SUBJECT: Discusses exception to Amend 22 to FSAR Subsection NE-4452 of Section III of ASME Code re liquid penetrant exam of surface defects removed by grinding. Exception is one-time departure & will be deleted from amend.

March 24, 1986  
(NMP2L 0666)

Re: Nine Mile Point Unit 2  
Docket No. 50-410

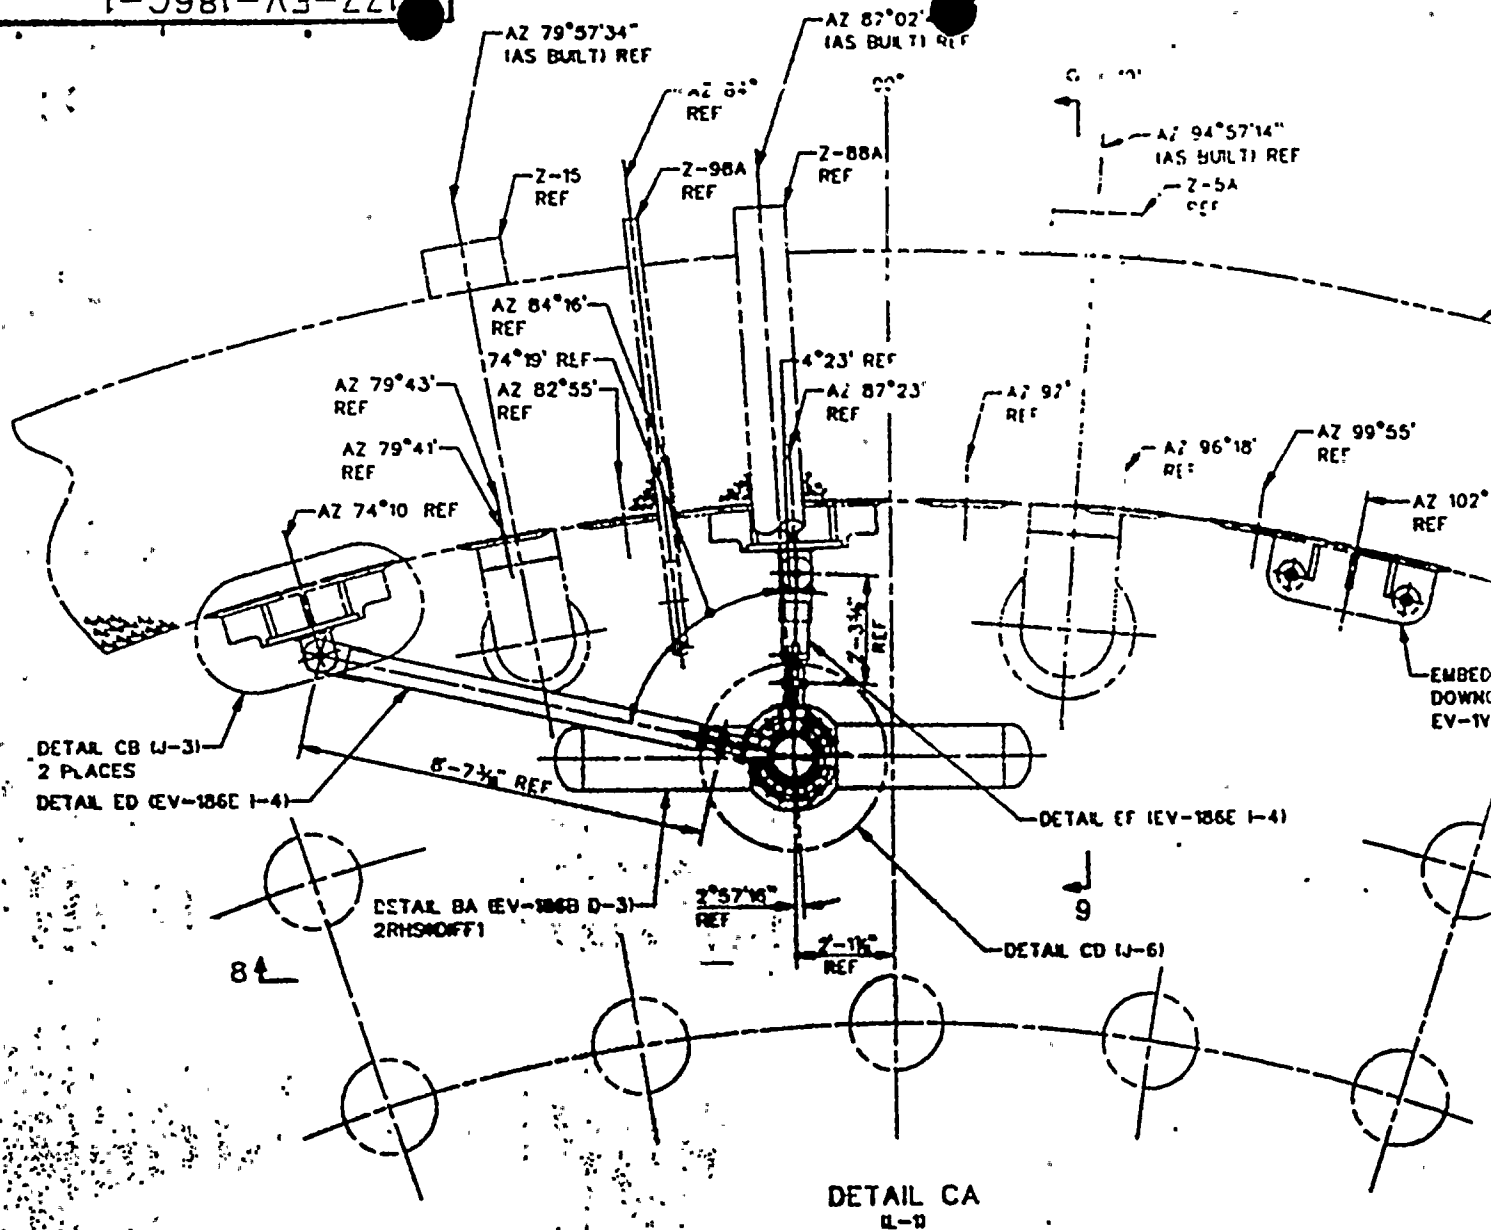
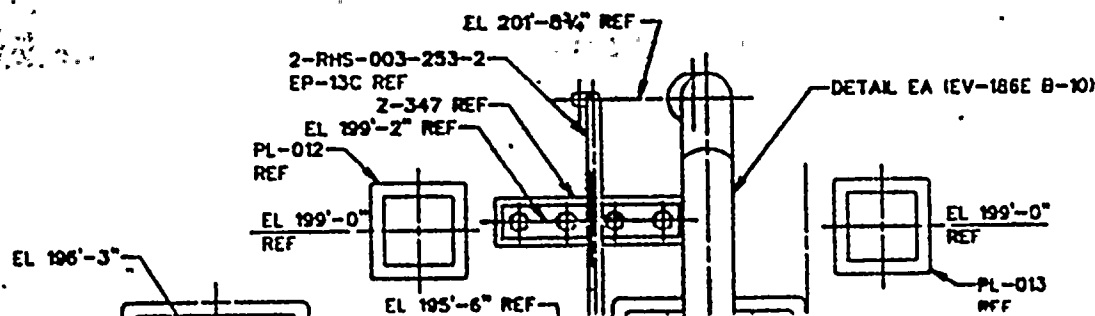
This exception to NE-4452 applied only to a 1-inch portion of a 10-inch long 1/2" x 3/4" fillet weld on one shelf-to-downcomer embedment plate located at elevation 196'-0", azimuth 74°10' (see attached drawing segments). This weld segment should have been liquid penetrant-tested in accordance with the ASME Code, Section III, Subsection NE, 1974 edition through winter 1976 addenda, following the removal of an arc strike by grinding. Instead, the weld was visually reinspected by ITT Grinnell in accordance with their field quality control procedure for visual examination. This examination provided adequate assurance that the arc strike was removed, and the remaining weld metal was sound and free of defects. Liquid penetrant reexamination is not now feasible as draining of the suppression pool would be required to gain access to the weld.

The subject embedment plate was originally intended to be used for bracing the downcomers. However, the plate has been modified and is now used for lateral bracing of a safety relief valve T-quencher. Calculations have shown that the plate is lightly loaded, with a factor of safety greater than ten. Thus, even if the suspect 1-inch of visually examined weld were to be neglected for strength considerations, it would still be concluded that the embedment plate is structurally adequate.

The above-described situation involves a one-time departure from NE-4452 and not a programmatic exception. Consequently, the exception will be deleted from the Final Safety Analysis Report by Amendment 25.

SKETCH TAKEN FROM DETAIL "CE" OF EV 186C-1

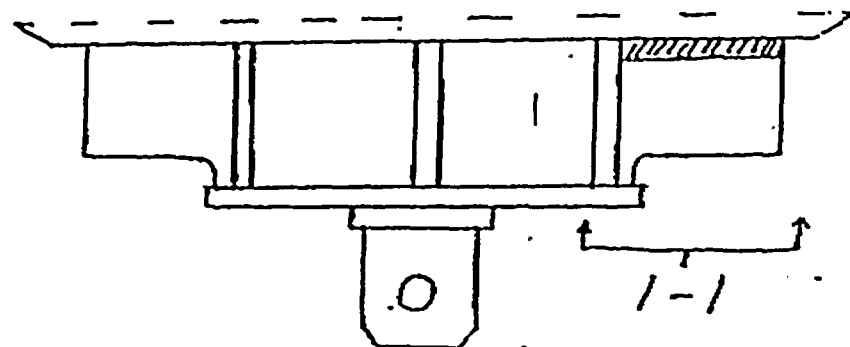
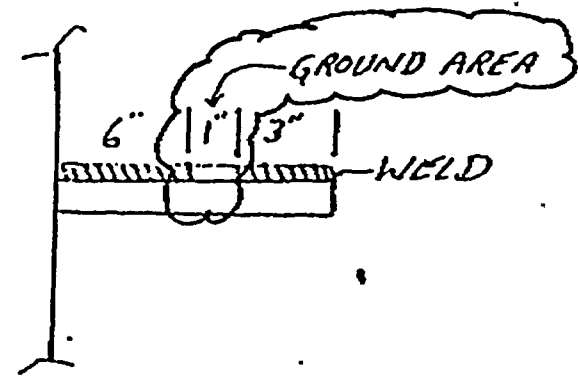
23901	ISON 66-11
EV 186C-1	WELDER VENDOR
NA	HOLD TAG# NA
NA	DEFECT CODE F2
